**Project: South Battery Park City Resiliency Project:
Wagner Park / Museum of Jewish Heritage
Site Work Construction Services Project
(the “Project”) Request for Proposals (“RFP”)**

Date: June 28, 2022

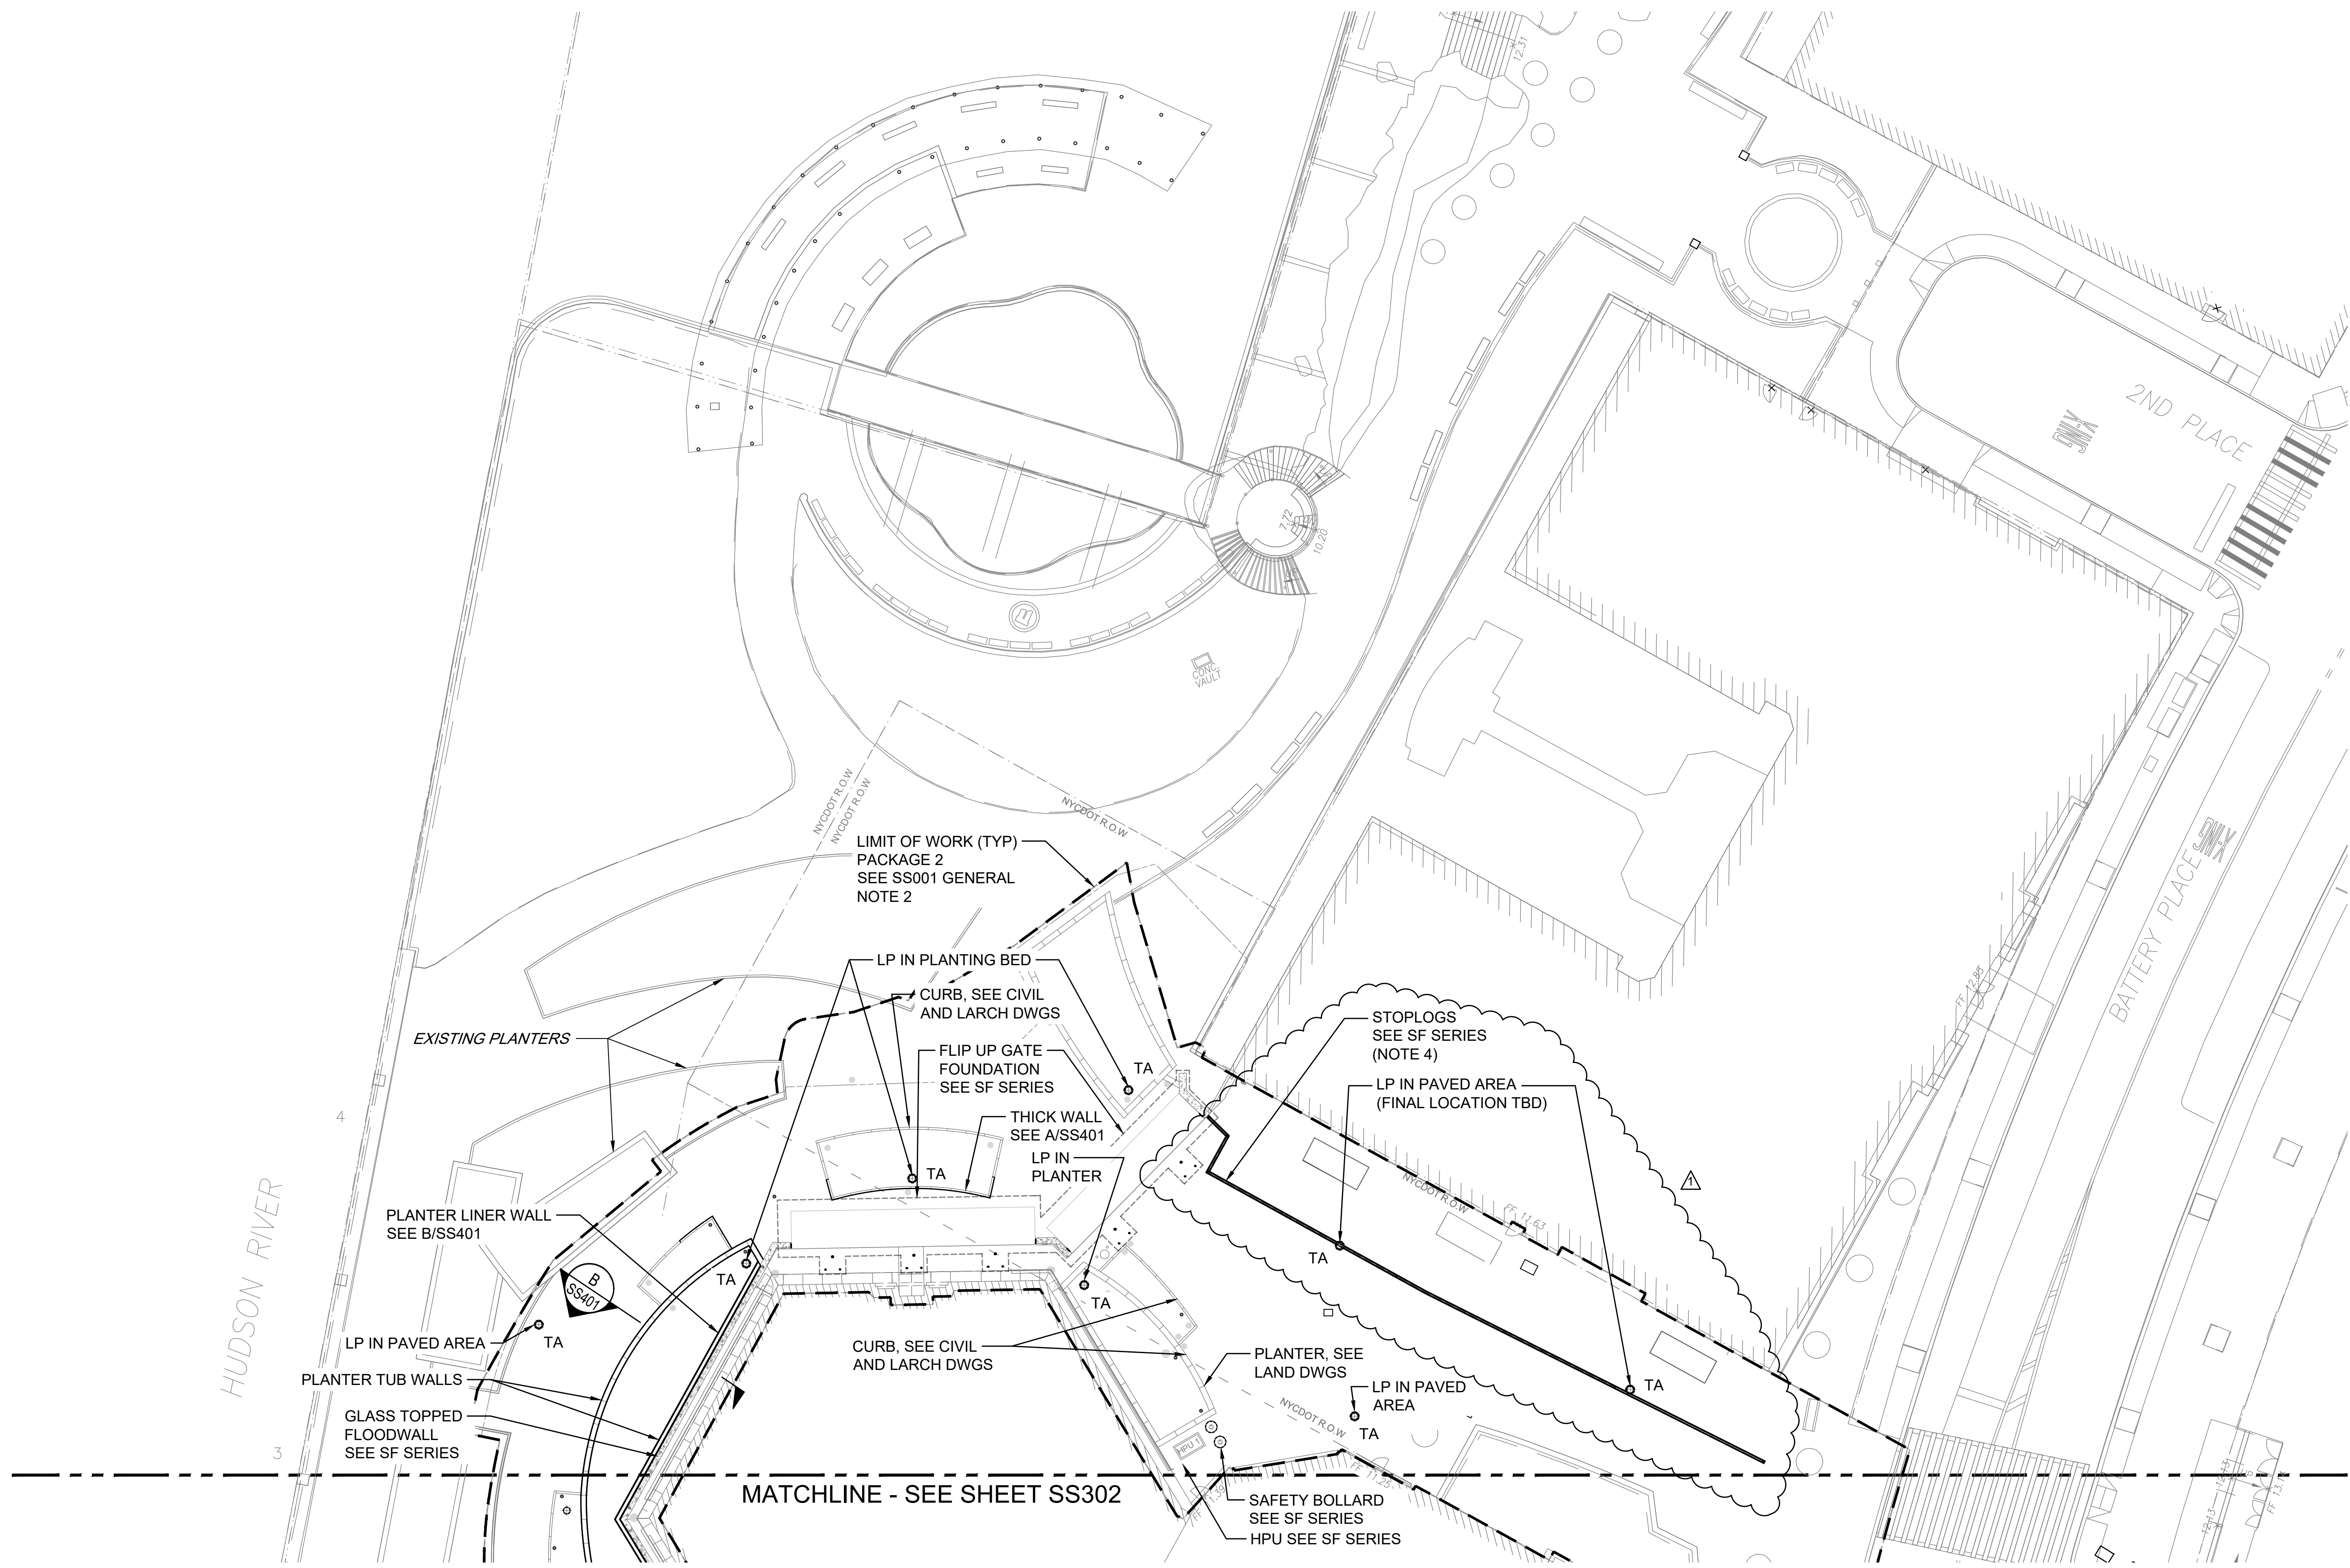
- NOTES:**
- SEE LANDSCAPE DRAWINGS FOR FINISHES AND ELEVATIONS.
 - SEE CIVIL DRAWINGS FOR GRADING.
 - SEE SF SERIES FOR FLOODWALL ALIGNMENT AND DETAILS.
 - FIRST PLACE WORK IS BEING COORDINATED WITH CONED AND LAYOUT AND DESIGN WILL BE UPDATED IN AN ADDENDUM.
